**SHEPARD
HILL**

PLAINFIELD, CONNECTICUT

ENVIRONMENTAL REVIEW TEAM REPORT
ON
SHEPARD HILL INDUSTRIAL PARK
PLAINFIELD, CONNECTICUT
JULY, 1975

TOPOGRAPHY

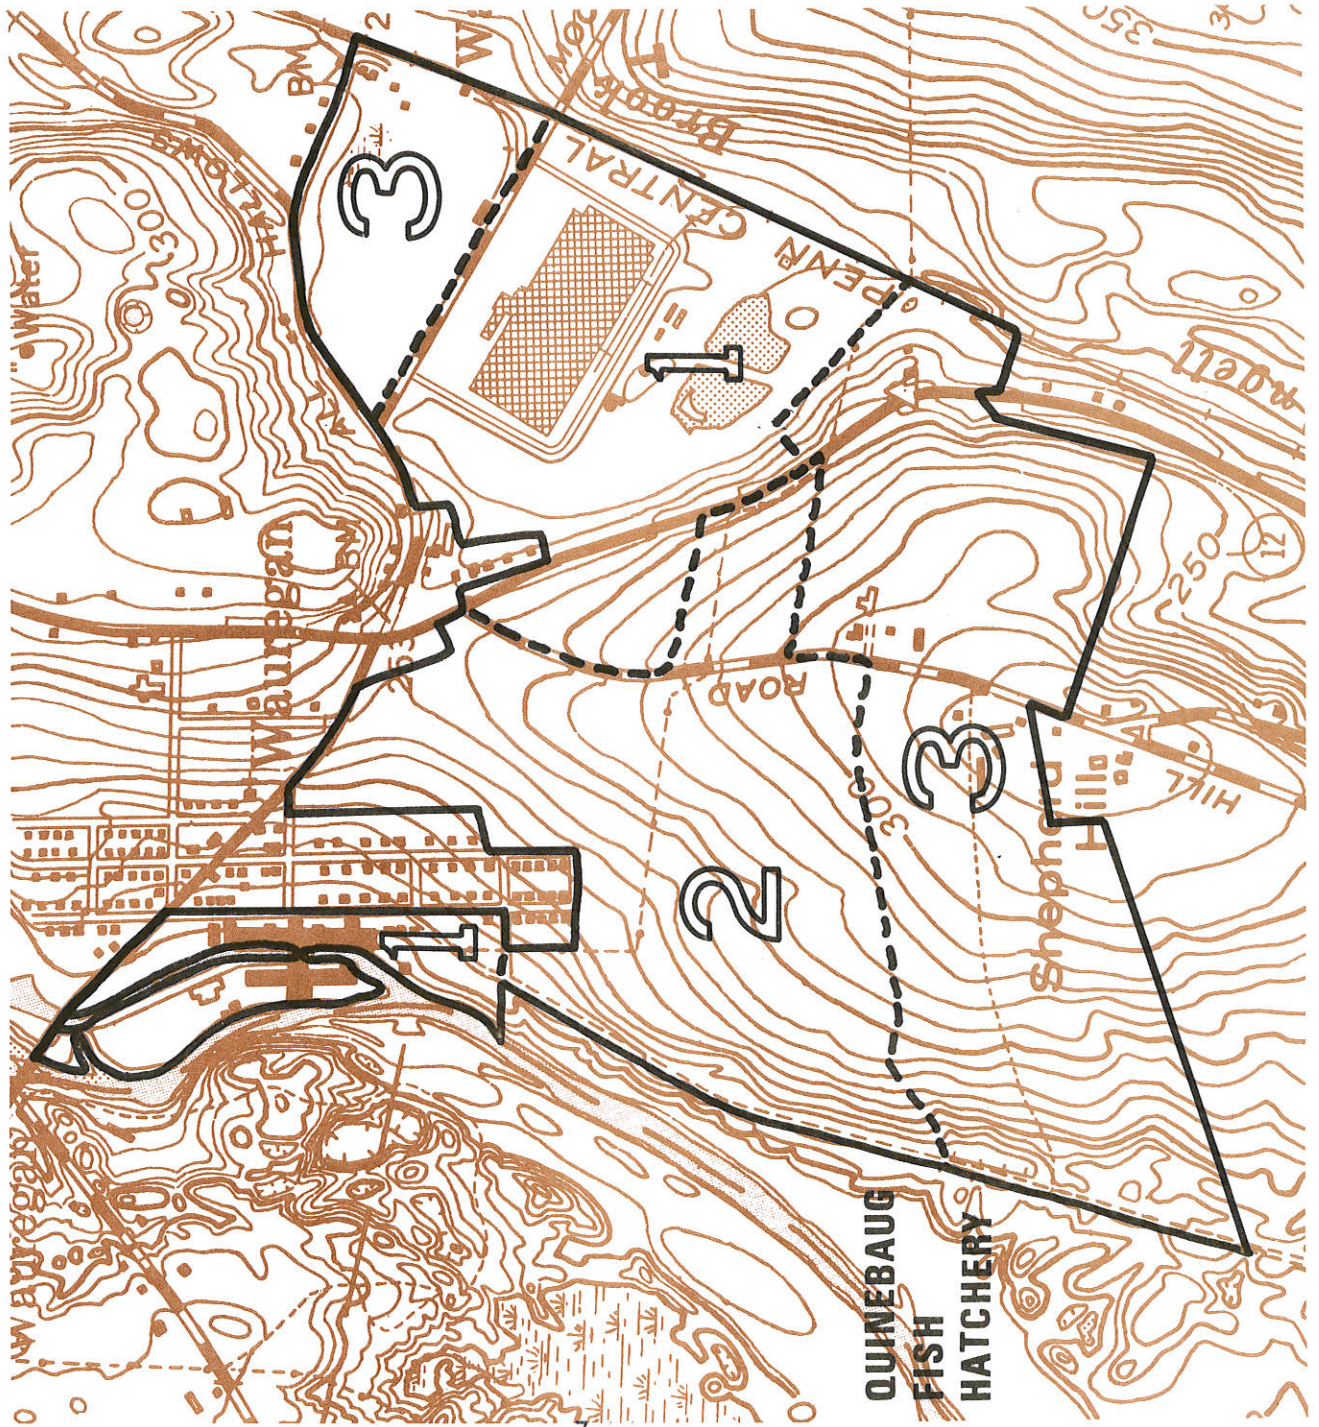
Under immediate consideration is an area of around 120 acres, located south of Route 205 and west of Route 12. There is an additional 150 acres which are being considered for future potential industrial expansion. This includes land south of the proposed site and north of Moosup Pond Road. About 60 acres of land between Shepard Hill Road and Moosup Pond Road are already developed industrially by the Novelty Textile Company and American Standard Corporation. (see Topography map on page 7 for locations of proposed and existing development).

Topography and Site Description. The site is located in northwestern Plainfield on the north-facing slope of Shepard Hill. This 160 foot hill forms roughly an ellipse with its long axis running north-south. Its elevation at the base is 180 feet above sea level and at the peak the elevation is 340 feet above sea level. The land slope of the proposed site is rather steep along the hill margins (10% to 13%) but becomes more gentle at the peak and along the main axis (3% to 7%) of the hill. A topography map is shown on the opposite page.

SURFICIAL GEOLOGY

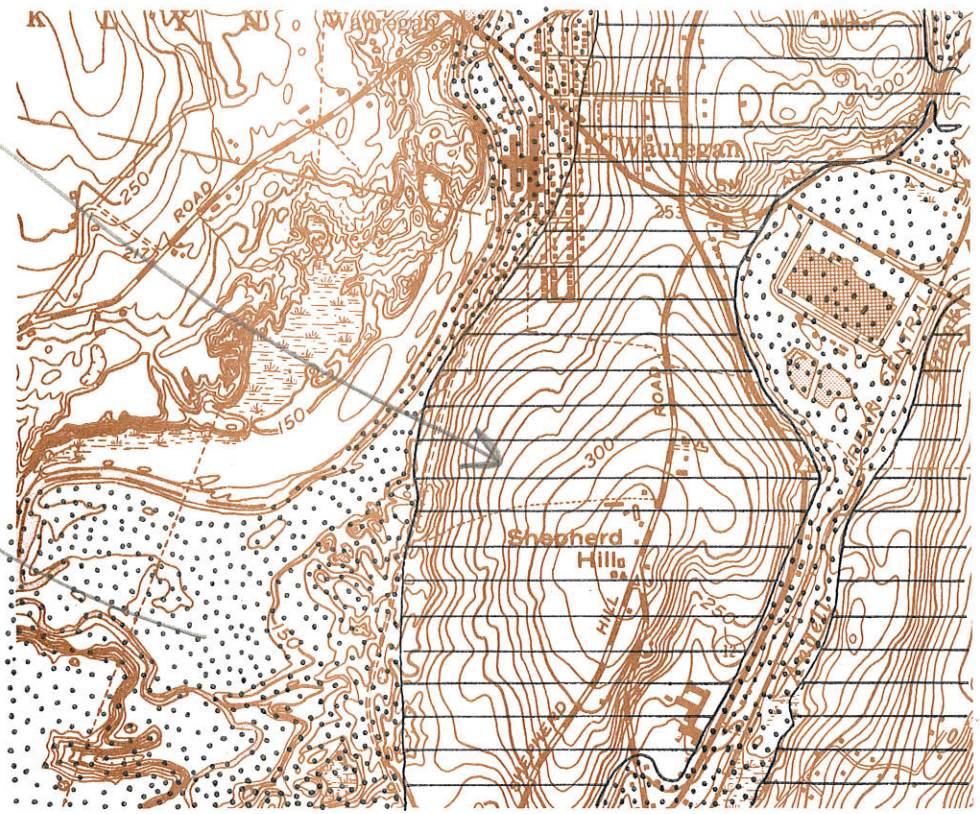
This soil is found on the western border of the site and corresponds with the stratified drift deposits shown on the surficial geology map. Permeability is rapid and the soil has a low water holding capacity and low natural fertility.

OTHER PHYSICAL FEATURES

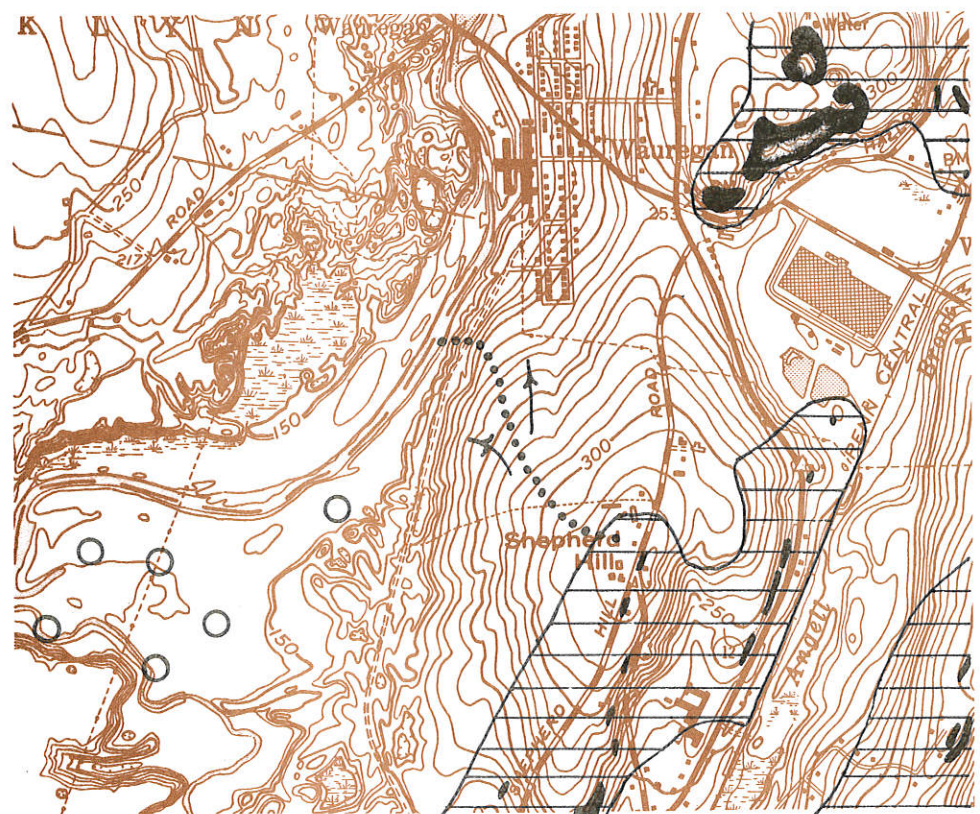
Shepard Hill is cored by bedrock but the depth to rock varies from place to place as a result of glacial action in the past. Huge amounts of rock and rubble were piled up against existing rock ridges and remained after the glacial ice melted away. This is the typical situation for many of the till hills (drumlins) of eastern Connecticut. Characteristically they are steep sloped and exhibit bare rock along the southern and southeastern sides while overburden is thicker and the slopes are more gentle along the northern and northwestern margins. Because the industrial site would be located on the northern section of Shepard Hill, the thickness of till materials probably is greater than 10 feet but less than 30 feet with the average being closer to 15 feet to 20 feet. (See page 8 for a map showing rock outcrops and areas less than 10 feet to bedrock.)

Fisheries. As mentioned before, the Quinebaug Trout Hatchery, owned and operated by the State, is located adjacent to the western boundary of the proposed industrial park. The map on page 8 shows the location of the six wells which are currently being used to provide water for the hatchery. The Quinebaug River by itself is a valuable resource and warrants serious consideration when development occurs on adjacent lands. With the hatchery present, even greater concern exists, particularly with respect to surface and subsurface runoff.

and herbicides from lawns, a high oxygen demand, and large amounts of heavy metals, notably lead and zinc. Based on the topography it appears pollutants carried by overland runoff from most of the proposed site will be no threat to the hatchery's water supply since existing surface drainage patterns carry most water to the north and eventually into the surface waters of the Quinebaug (see drainage divide on west side of Shepard Hill on map on page 8).

However, there are places along the western portion of the proposed site that do drain toward the well system. Also, if care is not taken to maintain the existing predominant natural drainage system to the north during and after development, larger areas of the site may be diverted to drain toward the well system. The problem arises when polluted runoff flows to the west and reaches the till - stratified drift contact. At this point, because the sands and gravels take in surface water rapidly, whereas till does not, any contaminated fluids pass easily and quickly to the ground water table where it flows toward the river in a south-westerly direction. If wells on the floodplain are withdrawing water there is always the possibility that some diluted form of this runoff from the industrial park may be taken up with the well water. The effect, if any, cannot be known at this point in time or from this level of investigation. However, it would be safe to say by planning a development program which minimizes over land runoff from the site to the till-stratified drift recharge area along the western boundary, there should be little or no effect on ground water quality in this area. Methods to accomplish this may range from diverting the existing westerly drainage to the north where possible to leaving an undeveloped buffer strip along the western property boundary.
